July 16, 2021

Product Improvement Notice - Inner hinge extrusion redesigned for baggage doors

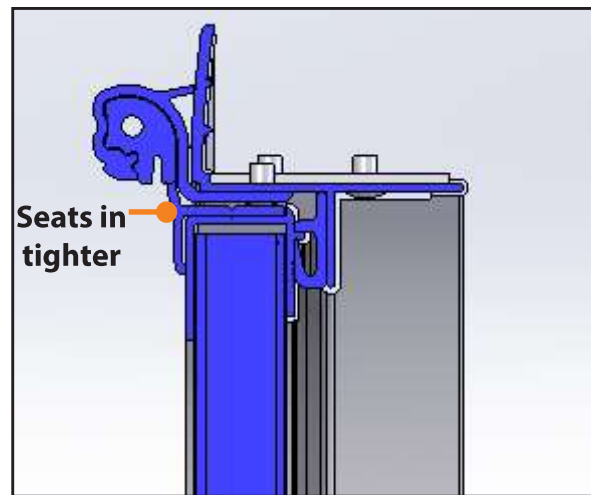
Please be advised Lippert has redesigned the inner hinge extrusion on its baggage doors to improve the door's reveal near the hinge.

The new inner hinge extrusion sets in the outer extrusion better to make a tighter reveal for the door. There is no change in installation or operation with the improved hinge redesign. There is no part number change and no price change.

**Current inner hinge extrusion
with outer extrusion.**

**New inner hinge extrusion with
outer extrusion.**

With current inner hinge

With new inner hinge
